Replacement from PM-L24

The recommended substitute of PM-L24 will be **PM-L25**.

Differences of mounting

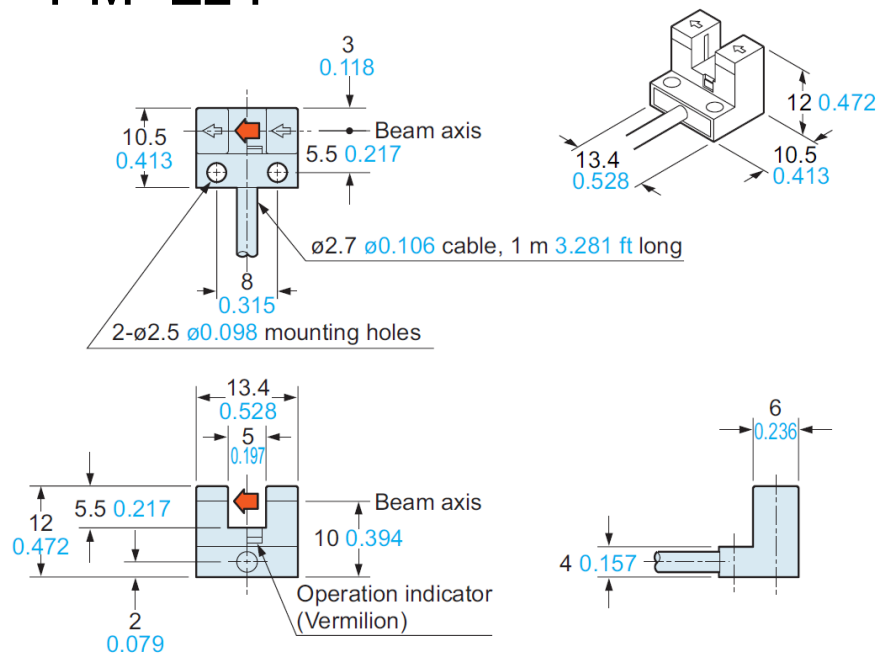
-  Outline becomes larger.
-  Mounting hole becomes larger. 2- ϕ 2.5mm/ ϕ 0.098in mounting hole. \Rightarrow 2-elongated mounting holes.
-  The mounting hole pitch is the same at 8mm/0.315in.
-  M2 mounting only. \Rightarrow M2 and M3 mounting possible.
-  In case of M2 installation, conventional mounting holes can be diverted, but a washer is necessary.
